| Memo | |
|---|---|
| Subject | Amendment No. 7 Architectural Services Agreement –LCA Architects – Fremont High School New Construction Project - Division of Facilities Planning and Management |

AMENDMENT NO. 7

ARCHITECTURAL SERVICES AGREEMENT

This Amendment is entered into between the Oakland Unified School District (OUSD) and <u>LCA Architects.</u> OUSD entered into an agreement with CONTRACTOR for services on **March 13, 2016** ("Agreement"), and the parties agree to amend the Agreement for the Services with **Fremont New Construction Project** as follows and in the attached Exhibit A:

116833 BULLETIN #4-004.5

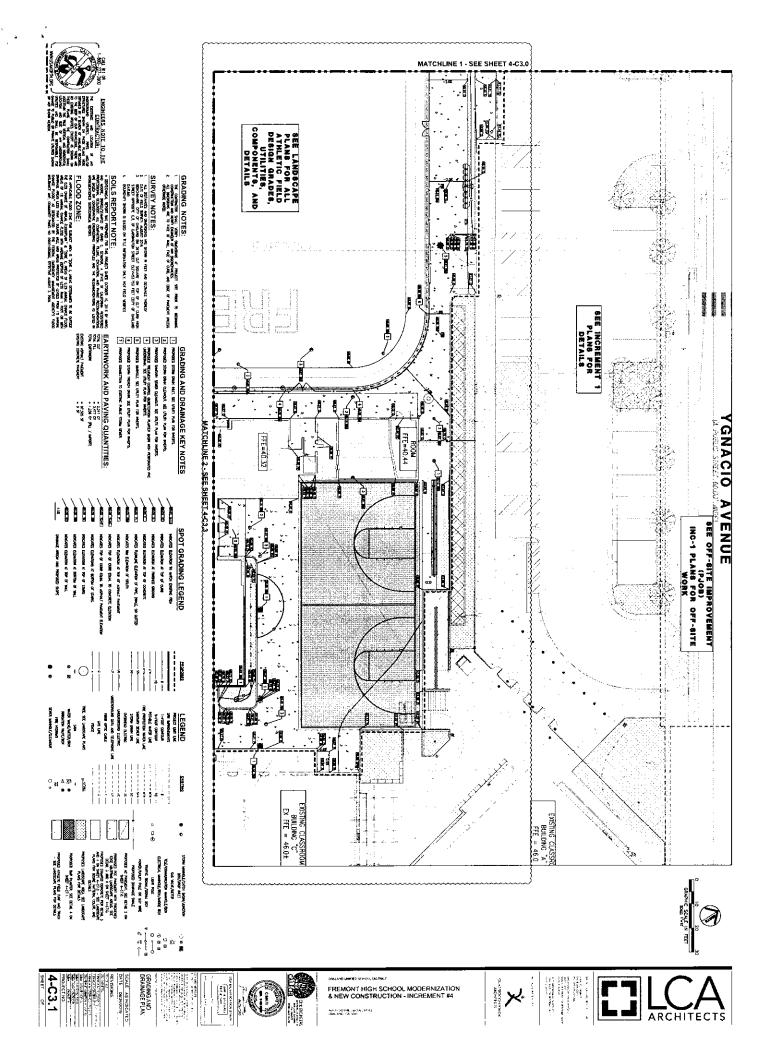
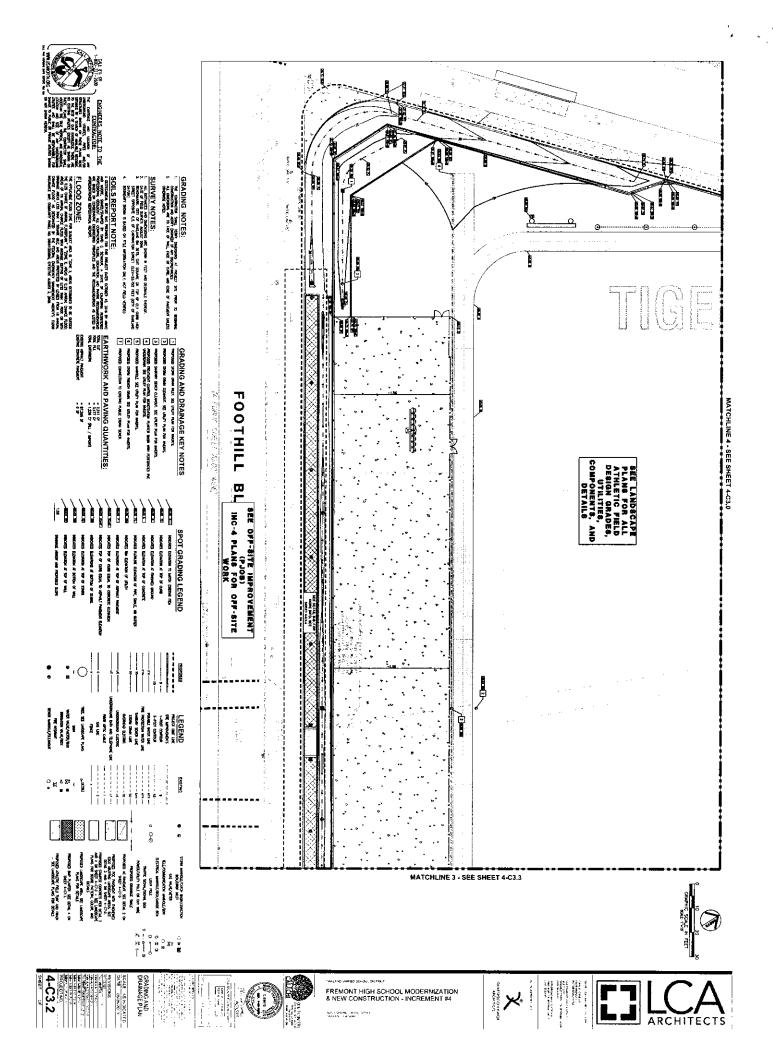
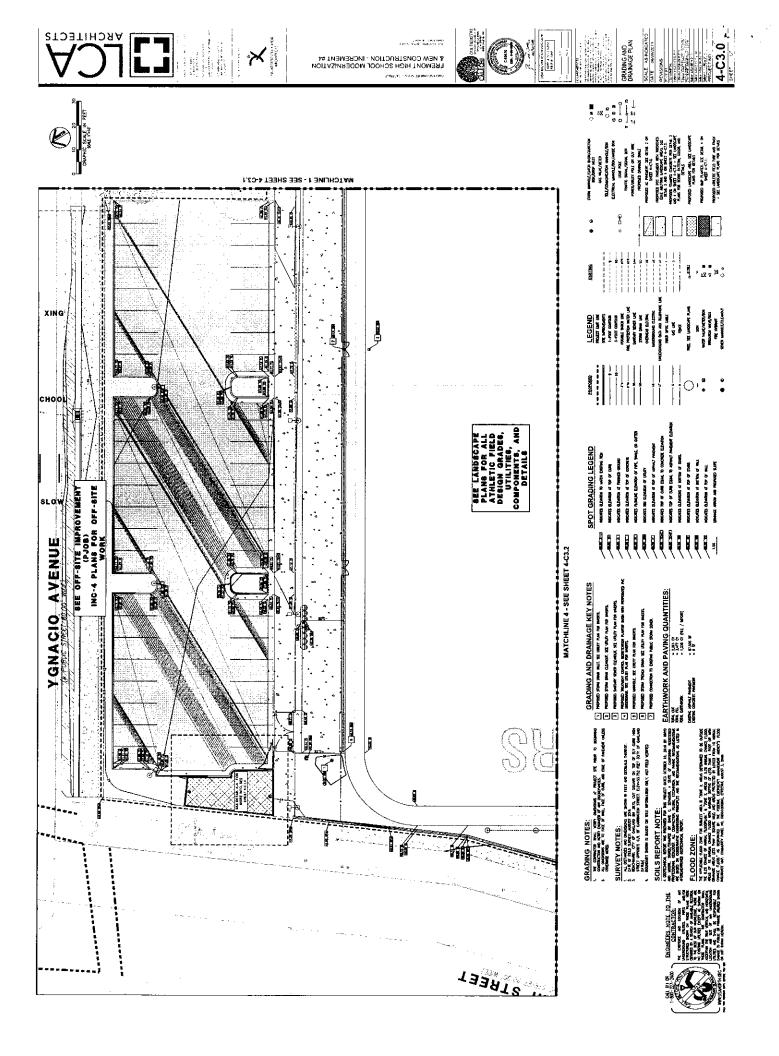
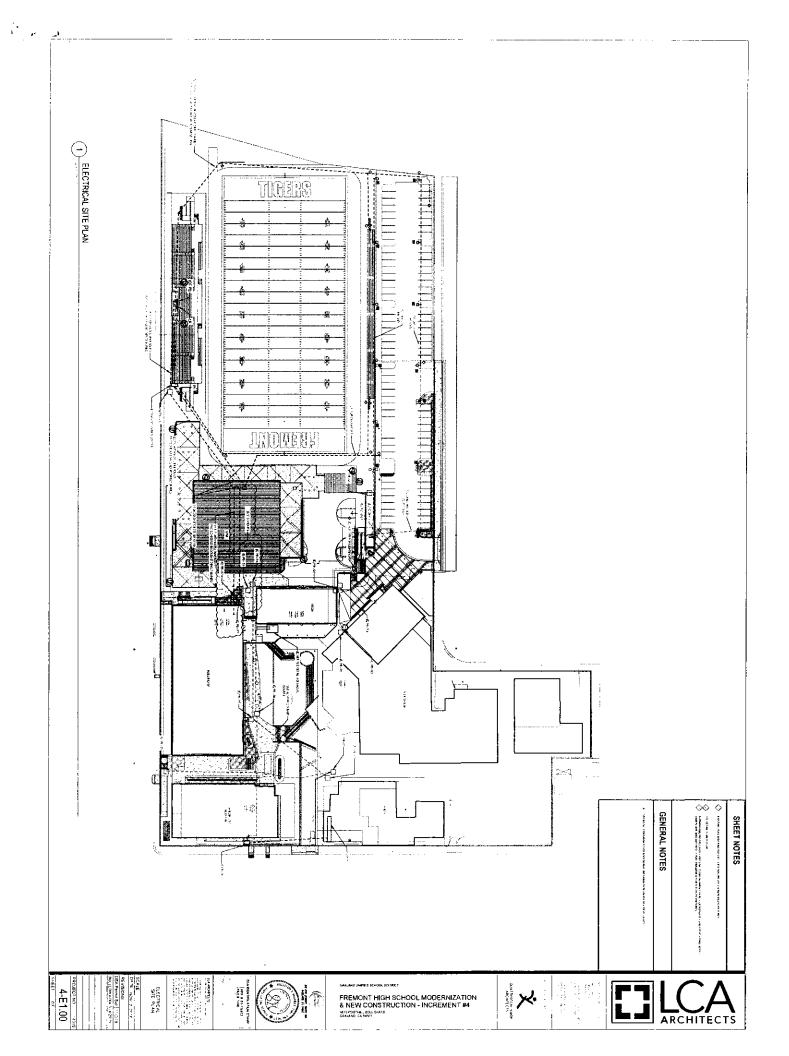
Grading and Drainage Sheets: 4-C3.0, 4-C3.1, 4-C3.2, 4-C3.3, 4-C3.4 •

116833 BULLETIN #4-015

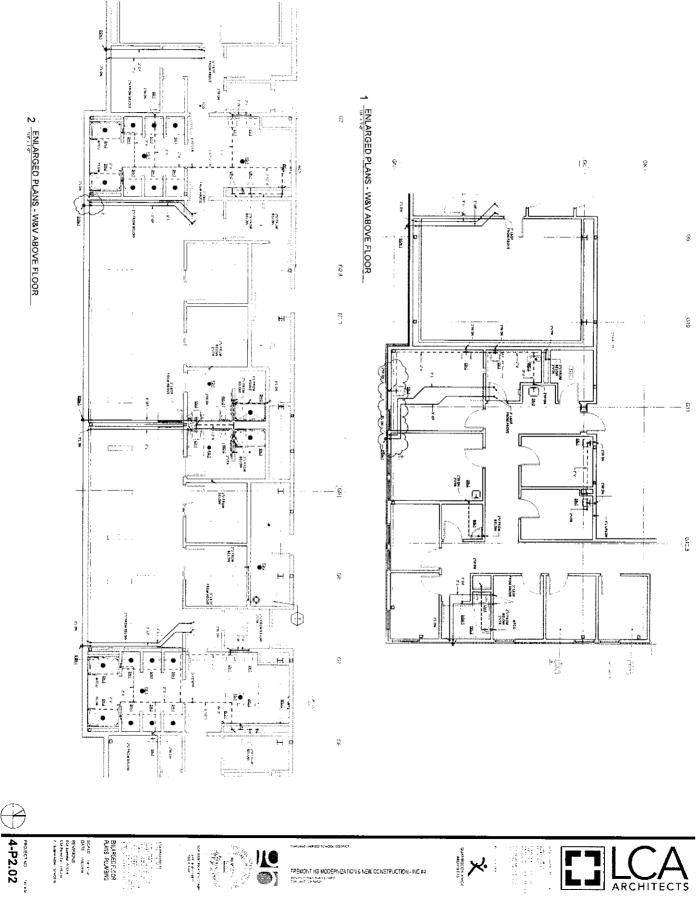
Bulletins 4-004, 4-004.1, 4-004.2, 4-004.3, 4-004.4, and 4-004.5 were issued to respond directly to underground utility coordination involving multiple iterations to the drawings. Bulletin 4-015 provided revised grading plans.

4-P2.01

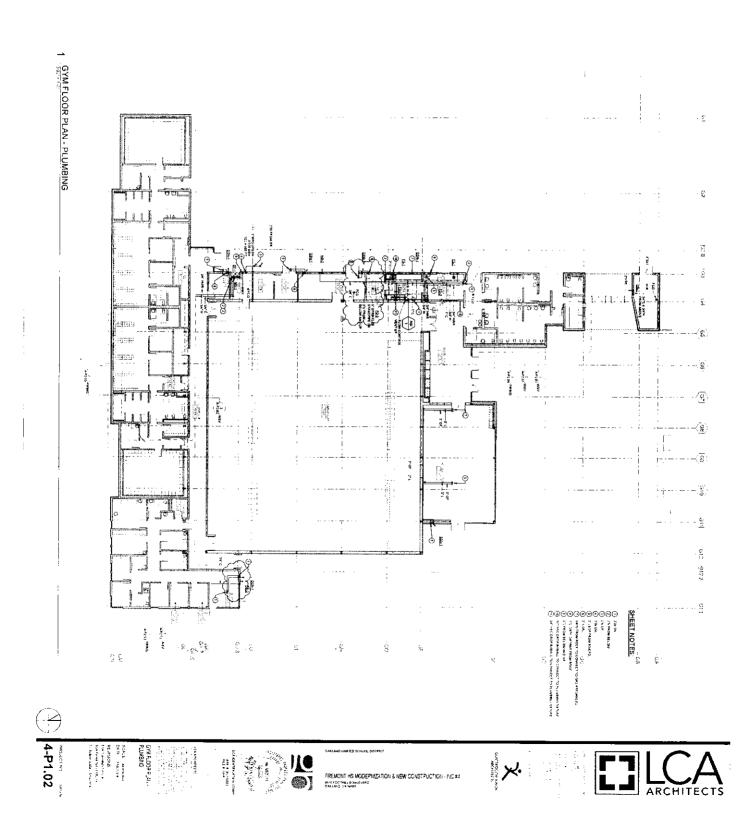
- Revised bulletin 4-004.1 adds two plumbing sheets (4-P2.01 and 4-P2.02) documenting revisions in response to RFI 4-037.1 and RFI 4-044 related to furring behind urinals and piping outside of walls.
- This bulletin provides revised civil utility plans and underground plumbing plans in response to the following RFI's: 4-039 Plumbing Stub Outs, 4-040 FSR Location (see also CCD 4-003 pending DSA Approval), 4-045 Storm Drain, 4-049 Conc Duct & SD, 4-050 Utility Pole & SD.

EAST ELEVATION

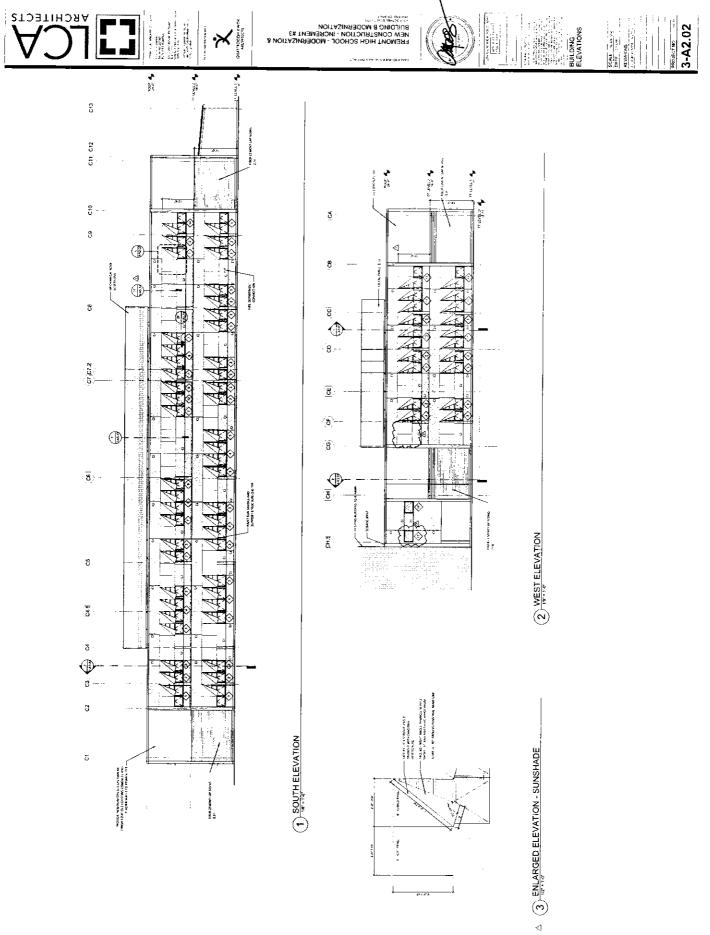
3-006.1 adds Sheet 3-A2.01 and identifies control joints on both elevation sheets. The other sheets are unchanged.
